SERIAL: HNP-01-059  
10CFR50.4

SHEARON HARRIS NUCLEAR POWER PLANT  
DOCKET NO. 50-400/LICENSE NO. NPF-63  
STEAM GENERATOR REPLACEMENT  
LICENSE AMENDMENT REQUEST  
ERRATA SHEETS

ERRATA SHEETS FOR ENCLOSURE 6 TO HNP-00-142, DATED OCTOBER 4, 2000

ERRATA SHEETS FOR WCAP-15399 (Non-proprietary)

Figure 6.1.3-1 Post-LOCA Sump Boron Concentration

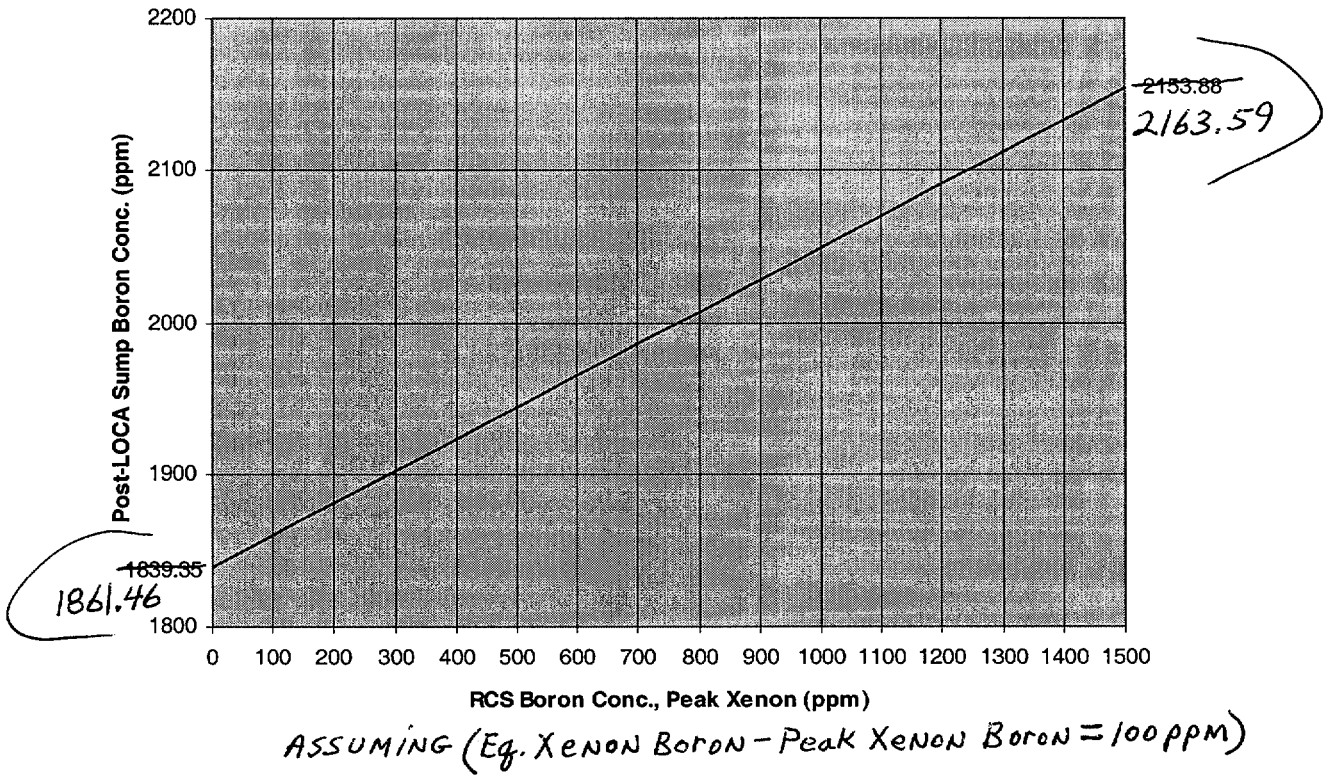
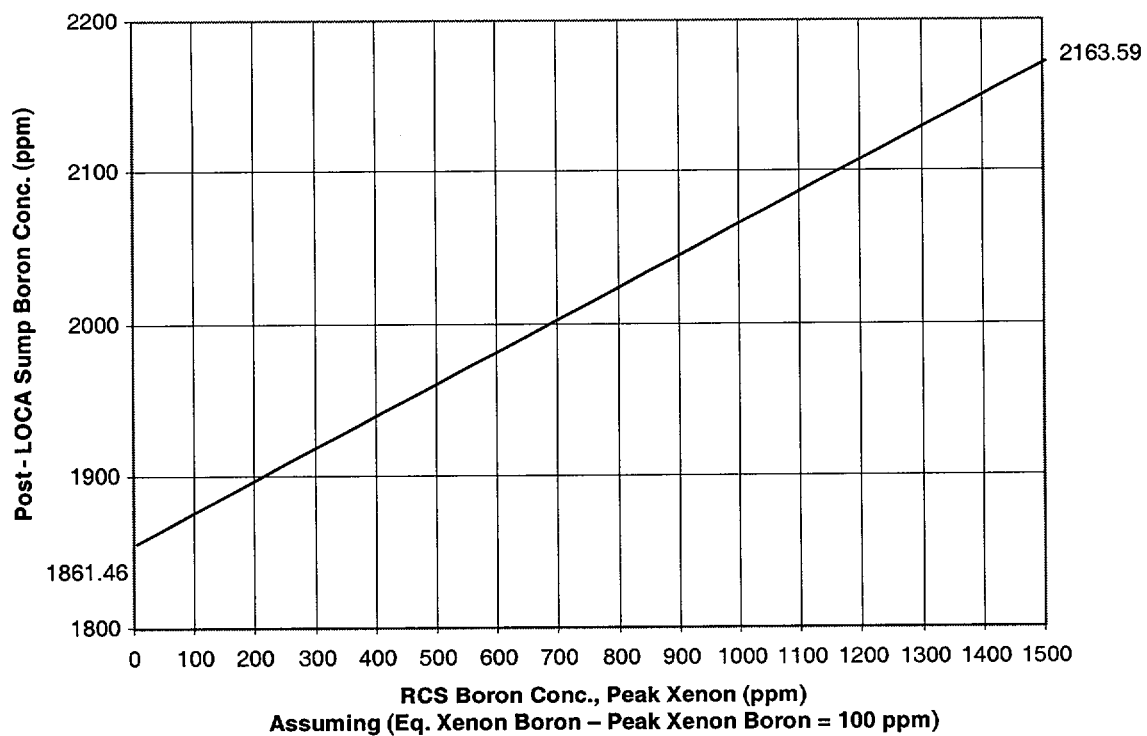
Mixed Mean Sump Boron Calculation: The results were tabulated for RCS boron concentration of 0 and 1500 ppm assuming the pre-trip RCS boron concentration for peak xenon concentration to be 100 ppm lower than the equilibrium xenon case. The straight-line curve (See Figure 6.1.3-1.) fit for the two points provided above is:

$$\begin{matrix} \rightarrow & & 0.20142 \\ & & y = 0.20969x + 1839.35 \\ & & \quad \quad \quad 1861.46 \end{matrix}$$

$$\begin{matrix} \rightarrow & & 0.20142 & 0.03653 & 1857.81 \\ & & y = 0.20969x + 0.038036n + 1835.542 \end{matrix}$$

Mixed Mean Sump Boron Calculation: The results were tabulated for RCS boron concentration of 0 and 1500 ppm assuming the pre-trip RCS boron concentration for peak xenon concentration to be 100 ppm lower than the equilibrium xenon case. The straight-line curve (See Figure 6.1.3-1.) fit for the two points provided above is:

$$y = 0.20142 x + 1861.46$$

$$y = 0.20142 x + 0.03653 n + 1857.81$$

Figure 6.1.3-1 Post-LOCA Sump Boron Concentration

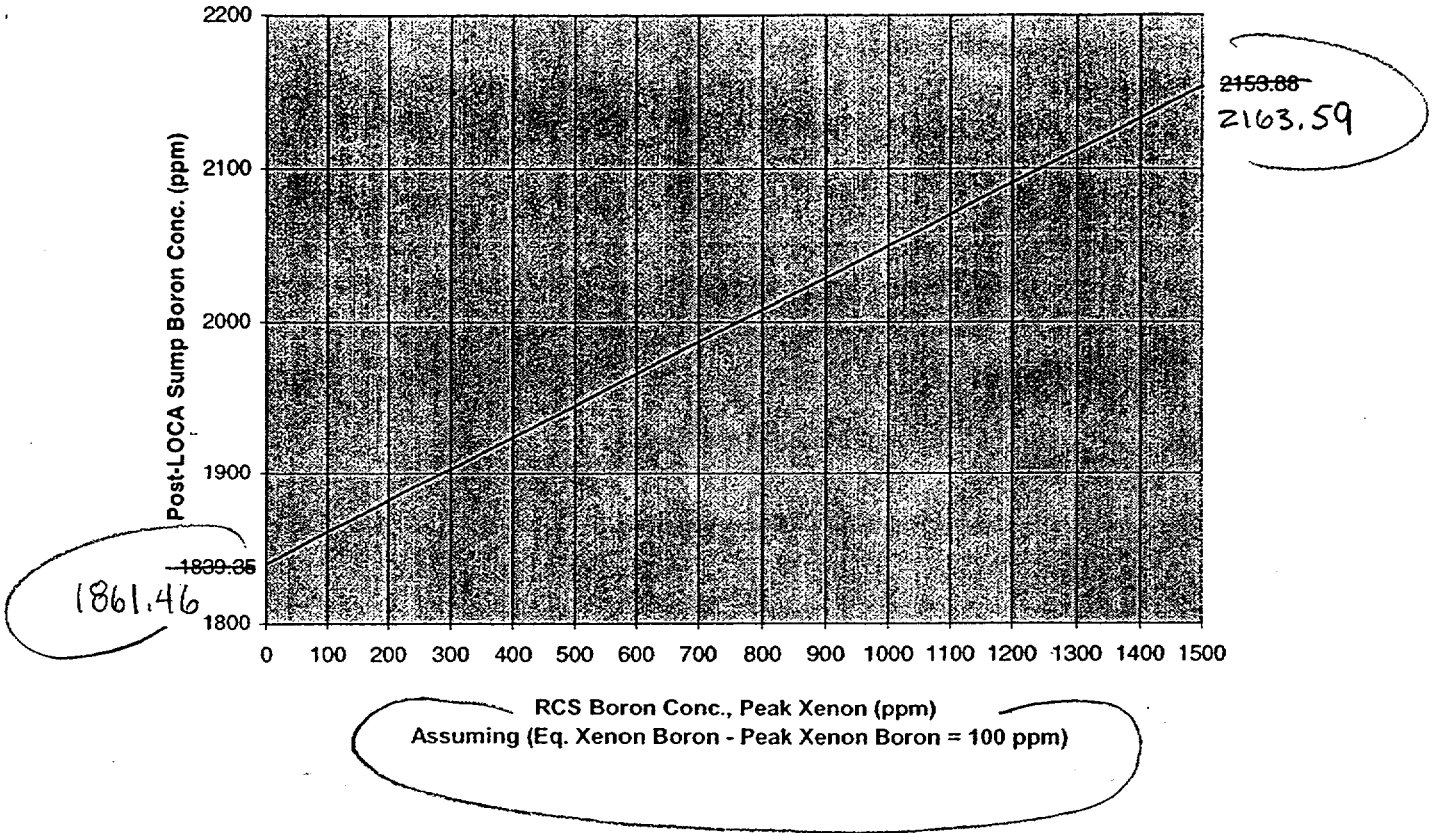
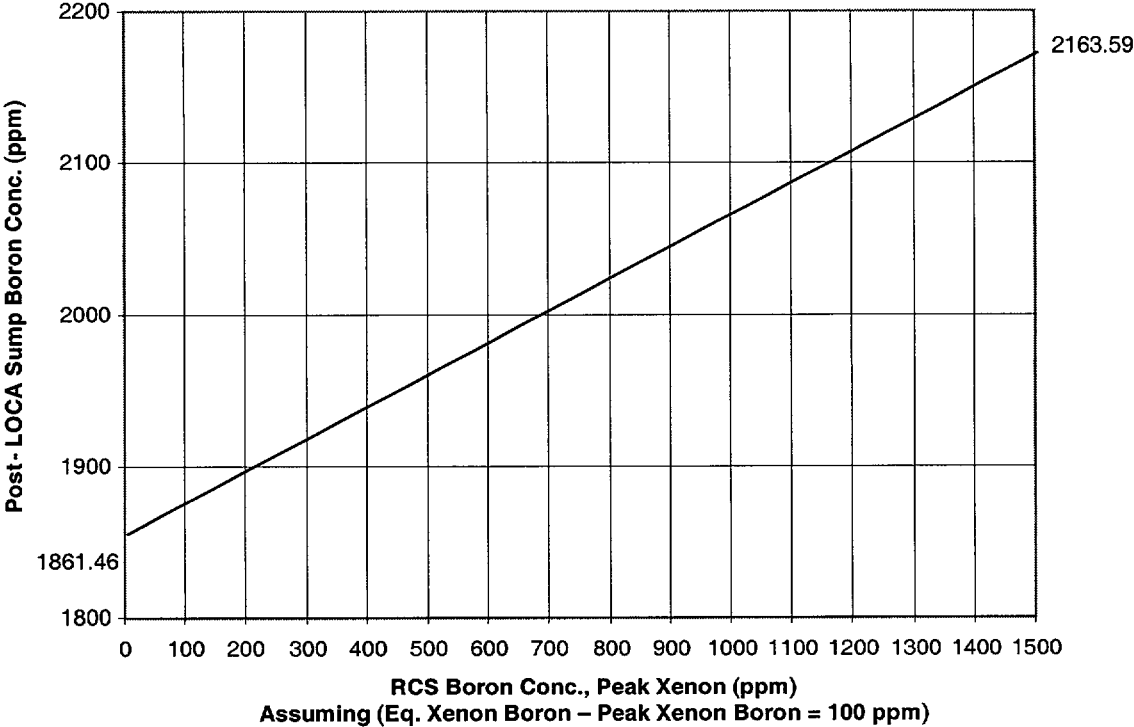
$$y = 0.20969 x + 1839.35$$

An alternate equation is provided below where "n" is the difference in boron concentration between the peak and equilibrium xenon concentration case. (See Figure 6.1.3-1.)

$$y = 0.20969 x + 0.038036 n + 1835.542$$

$$y = 0.20142 x + 1861.46$$

An alternate equation is provided below where “n” is the difference in boron concentration between the peak and equilibrium xenon concentration case. (See Figure 6.1.3-1.)

$$y = 0.20142 x + 0.03653 n + 1857.81$$
